Microcomputer Technical Information

Document No.	SBG-DT-03-0194-E 1/2
	Date issued	July 18, 2003
μPD789467 Subseries	Issued by	Microcomputer Group
		2nd Solutions Division
Usage Restrictions		Solutions Operations Unit
		NEC Electronics Corporation
Related documents	Notification	√ Usage restriction
μPD789467 Subseries Preliminary User's Manual:	classification	Upgrade
U15552EJ1V0UD00		√ Document modification
		Other notification

μ PD789467 Subseries Usage Restrictions

Case when an error of up to 1.5 clocks is generated

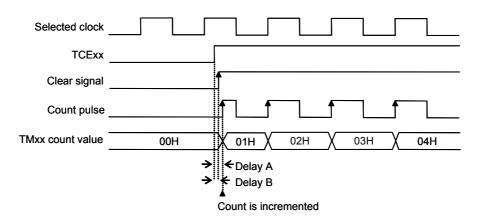
When the 8-bit timer/event counter is used, an error of up to 1.5 clocks is generated after the timer has been started until a match signal is generated. This is because a rising edge is detected when the timer is started while the selected clock is high, which results in the count value getting incremented.

If a count pulse is delayed for the clear signal ("delay A > delay B") as the result of setting the count operation flag (TCExx) while the selected clock is high, the TMxx count value is incremented. An error of up to 1.5 clocks is generated.

An error of up to 1.5 clocks is included in the time between the timer being started and a match signal is being generated.
